- 2 1 WOODBINE CRESCENT, RYDE - SECTION 4.55(1A) TO MODIFY DEVELOPMENT CONSENT FOR A DUAL OCCUPANCY. THE MODIFICATIONS INCLUDE EXTENSION OF THE LENGTH OF THE PATIO OF DWELLING 1, CHANGES TO THE DIMENSIONS OF A NUMBER OF WINDOWS, DELETION OF THE SWIMMING POOL OF DWELLING 1A AND INTERNAL RECONFIGURATION OF ROOMS - MOD2018/0228**

**City of Ryde
Local Planning Panel Report**

DA Number	MOD2018/0228
Site Address & Ward	1 Woodbine Crescent, Ryde Central Ward
Zoning	R2 Low Density Residential
Original proposal	Demolition, new dual occupancy (attached) and swimming pool.
Proposal	Section 4.55(1A) application to modify development consent for a dual occupancy. The modifications include extension of the length of the patio of Dwelling 1, changes to the dimensions of a number of windows, deletion of the swimming pool of Dwelling 1A, and internal reconfiguration of rooms.
Property Owner	Adib Obeid & Rony Obeid
Applicant	R Obeid
Report Author	Rebecca Lockart Senior Town Planner
Lodgement Date	10 September 2018
No. of Submission	7 submissions
Cost of Works	Section 4.55 application – Not applicable

Figure 5. Ground floor plan showing proposed amendments

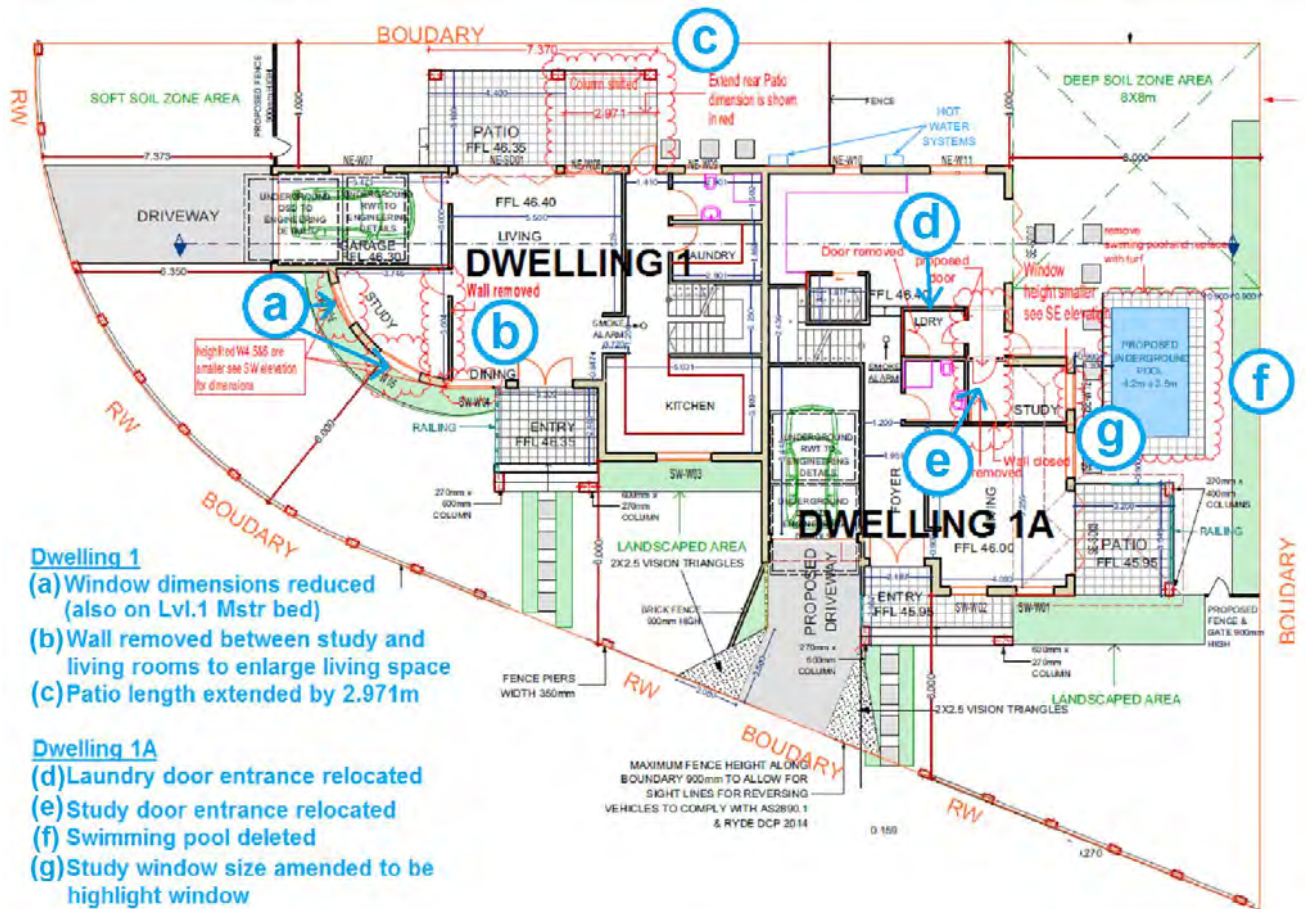
- a) Windows off the previous study to be reduced in size to 0.6m(w) x 1.4m(h);
- b) Deletion of the internal wall between the study and living room; and
- c) The patio and roof along the north-eastern elevation is to be increased from 4.4m in length to 7.37m.

- d) The internal laundry entrance door location amended;
- e) The internal entrance door to the ground floor study has been relocated;
- f) Swimming pool deleted; and
- g) The height of Window SEW12 on the ground floor study, has decreased from 1.5m to 0.595m (increasing the sill height to 1.805m above floor level).

The proposed modifications are outlined below and shown at **Figure 5**.

Figure 6. Site Plan from LDA2015/0466 Assessment Report identifying building setbacks and distance to neighbouring dwellings

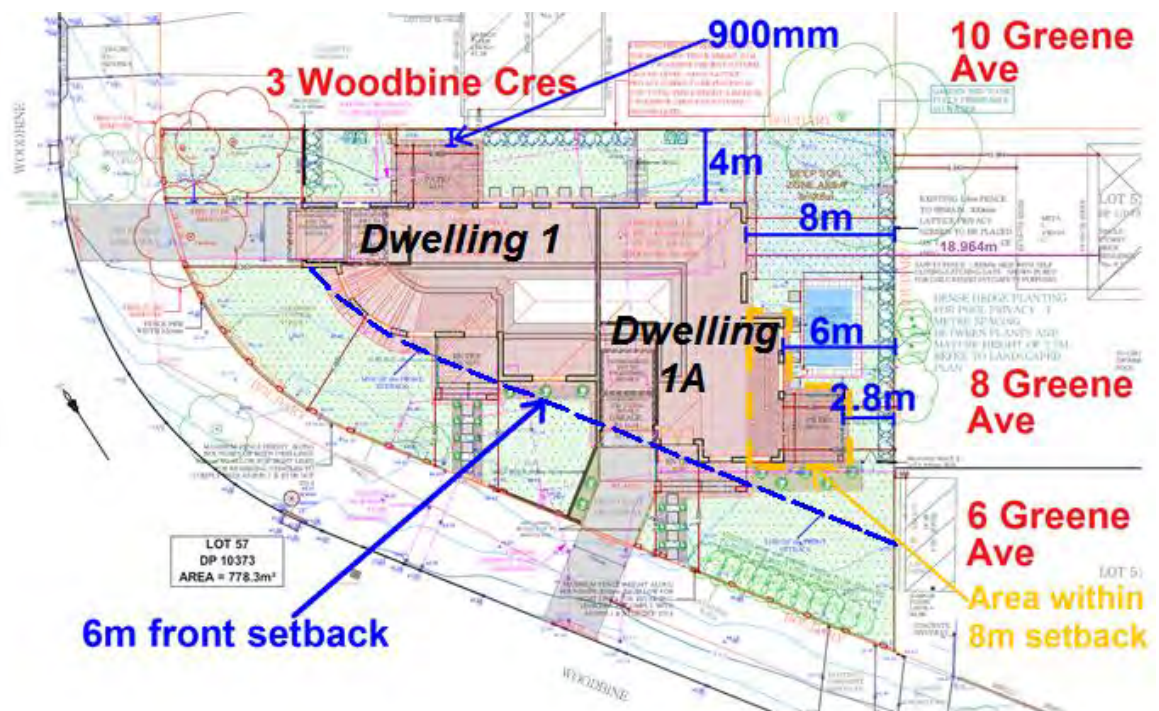
- The assessment contained in the original proposal outlined that the development has a separation distance of some 18.95m to the dwelling at 8 Greene Avenue, and approximately 1.93m to the garage at 3 Woodbine Crescent (see **Figure 6**). Photos at **Figure 7 and 8** below identify the visibility of the neighbouring dwellings from the patio and living room of Dwelling 1 (which received multiple submissions raising concern with privacy impacts).
- The proposed development modifies an approved dual occupancy development, which complies with the relevant planning controls for bulk and scale under Ryde LEP 2014, and the setbacks of the development have been approved as being satisfactory under the original approval of the development. Setbacks will not be changed under this application.
- The proposed changes will not cause any impact to the development potential of affected properties.

Figure 10. Photograph of the patio of Dwelling 1 looking west (1) and east (2)

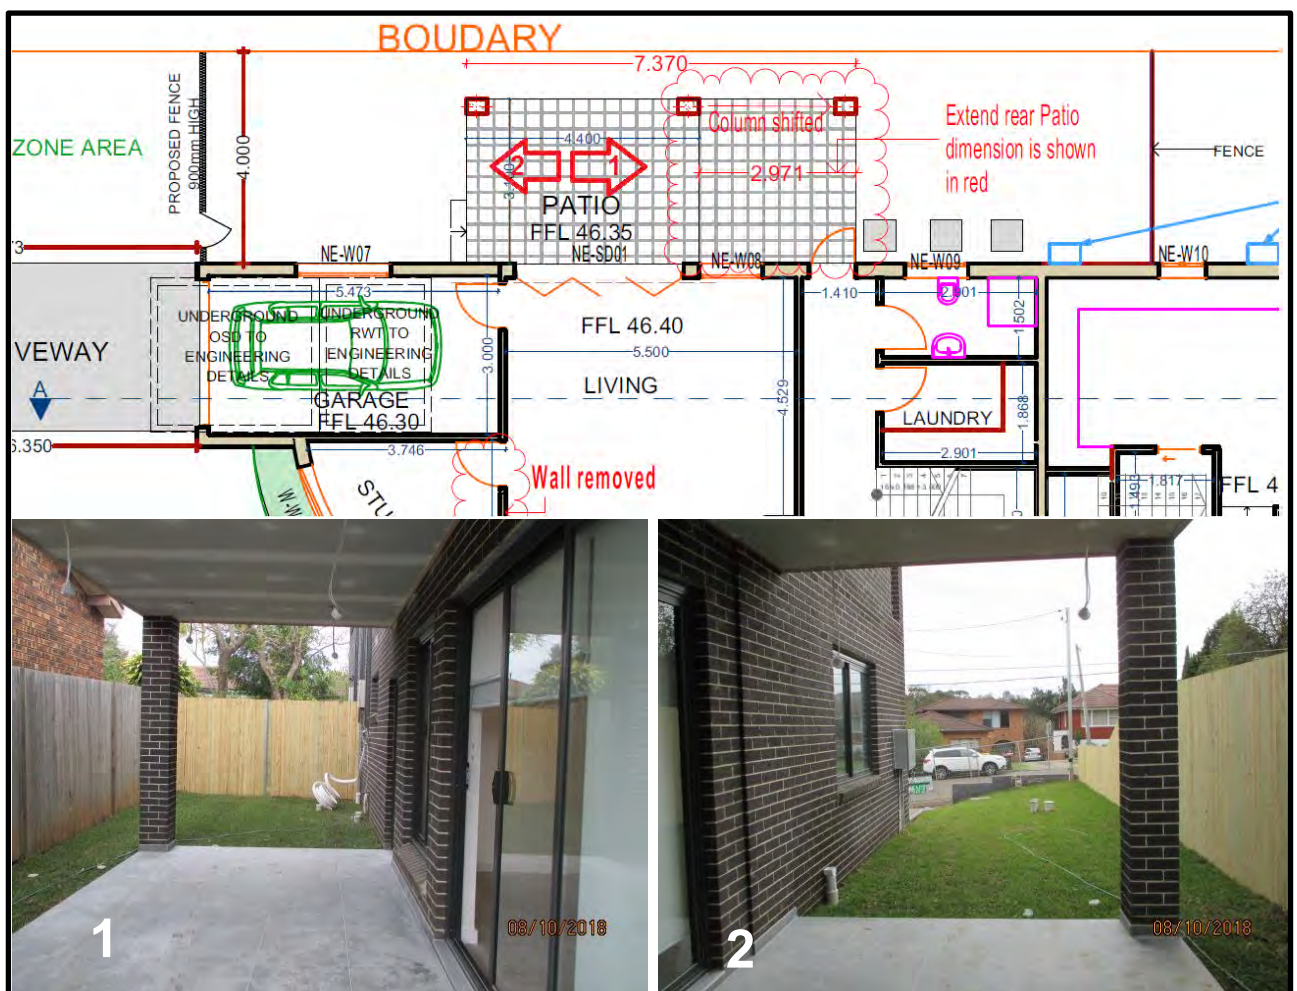
Comment: The patio has been increased in length by 2.971m as shown in **Figure 10** below. No other changes with regard to the height, materials or landscaping will change from that originally approved under LDA2015/0466.

The objections raise concerns that the increased area of the patio will have direct visual lines of sight into adjoining and neighbouring properties along Woodbine Crescent. This is because currently the patio that has been constructed is directly visible from the street (see **Figure 12**) as at present the soft and hard landscaping around the site has not yet been completed.

Figure 12. Excerpt of approved Landscape Plan under LDA2015/0466

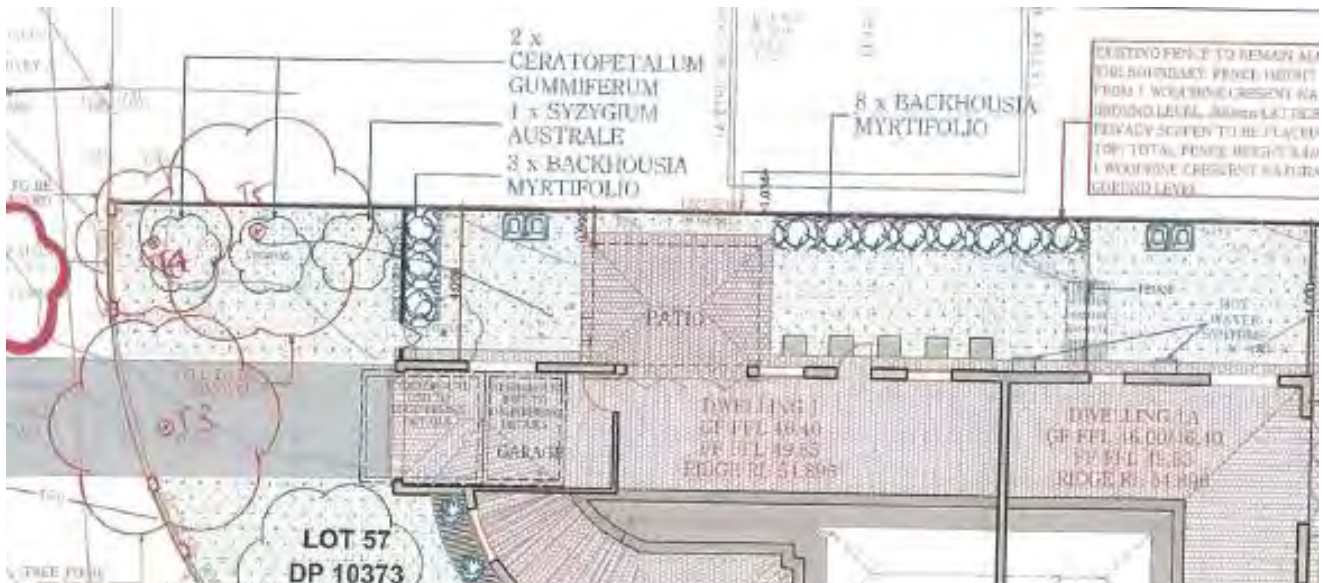
The approved landscape plans under the original approval includes a 900mm return fence along the front of Dwelling 1, in addition to 3 x Grey Myrtle (up to 4m) along the inside of the return fence, and 8 x Grey Myrtle along the boundary fence adjacent to the patio and 3 Woodbine Crescent. Additionally the front setback area has 2 x NSW Christmas Bush and 1 x Lilly Pilly (trimmed to 2m per Condition 1(d)) along the northern side boundary of the site as shown in the excerpt at **Figure 12**.
